**City of Lino Lakes  
Environmental Board Meeting**

**September 28, 2016  
6:30 p.m.**

**REQUEST:** Review: Lino Lakes Elementary-Site Plan  
Review/Conditional Use Permit

**TREE PRESERVATION PLAN**  
**L2-1**

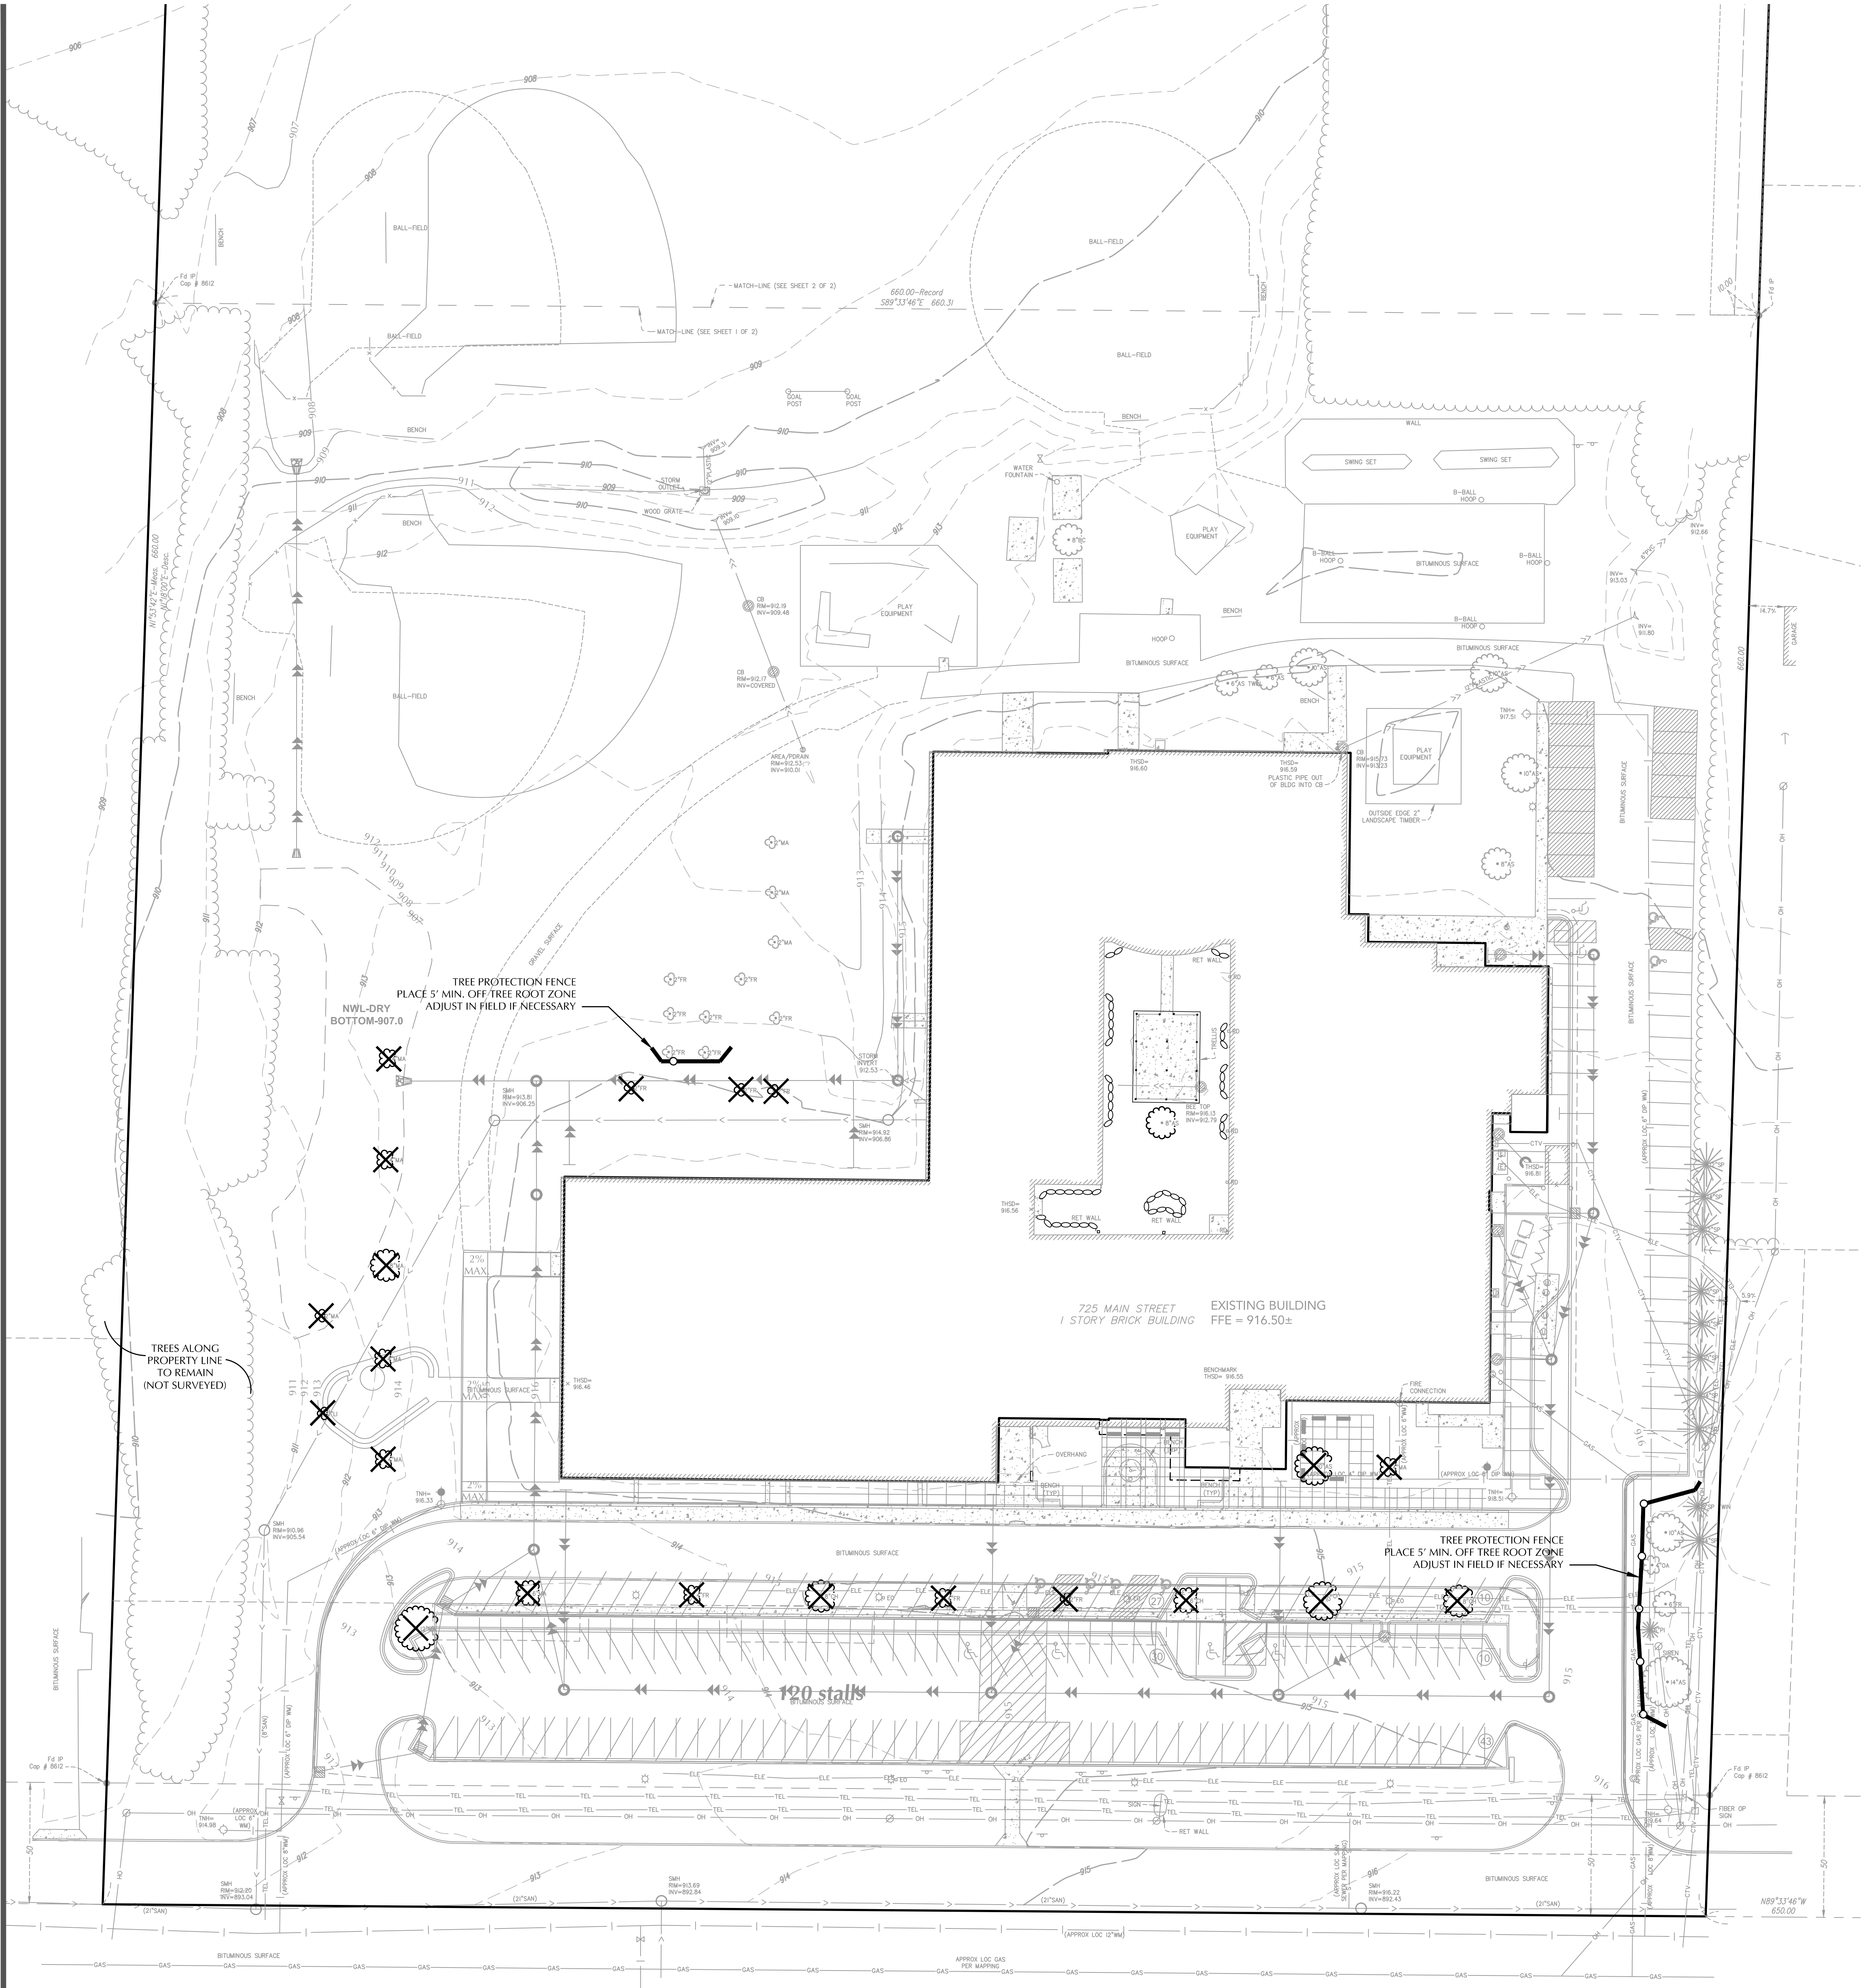
The school was built in 1992 prior to the regulations of the current landscape ordinance. However, new tree replacement standards were applied to Rice Lake Elementary and may apply here. The City Planner is looking at this.

All of the trees on the west side of the school, except for the windrow trees on the wetland border, and all of the trees in the parking lot island are scheduled for removal. Many of these trees were Arbor Day plantings, and some of them are trees that were dedicated to people.
